RE: Revised Attachment 9 and Joint Exhibits 2-3

**Montana-Dakota Utilities Co., a Division of MDU Resources Group, Inc.
Application for Advance Determination of Prudence Big Stone Air Quality Control
System Project
Case No. PU-11-163**

**Otter Tail Power Company Application for Advance Determination of Prudence
Big Stone Air Quality Control System Project
Case No. PU-11-165**

Re: Big Stone Plant Pro Forma Economic Analysis – Modeling Results
BMcD Project No. 57975

Figure 1 – Capital Cost Sensitivity Levelized Energy Costs

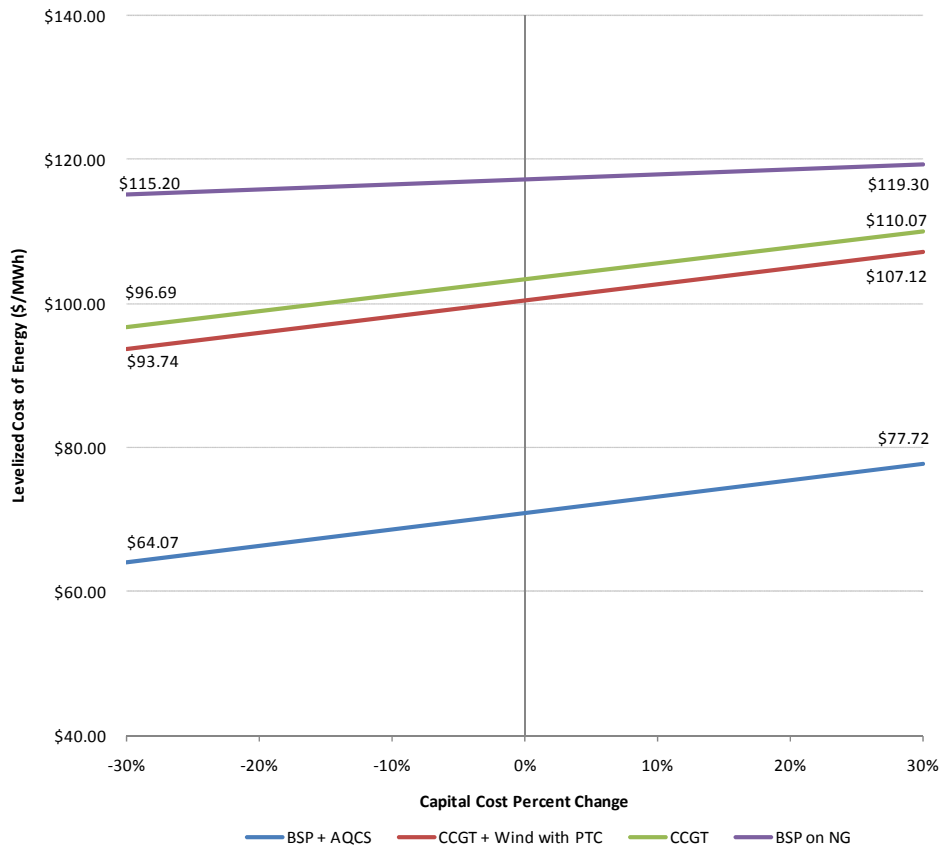
The heat rate input was a simple, clerical keystroke-error that resulted in analyzing a higher heat rate than is anticipated for the Big Stone Plant with AQCS. When corrected in the spreadsheet, the busbar energy cost for Big Stone Plant with AQCS is projected to be even lower than the original Attachment 9 reflects – and, therefore, more cost-effective vis-à-vis potential generation alternatives.

For filing we have enclosed an original and seven copies of Revised Attachment 9 and Revised Joint Exhibits 2 and 3, with corrected busbar energy cost figures for Big Stone Plant with AQCS. In order to assist the reader in identify revisions made, we are enclosing both clean and redlined versions of Revised Joint Exhibits 2 and 3.
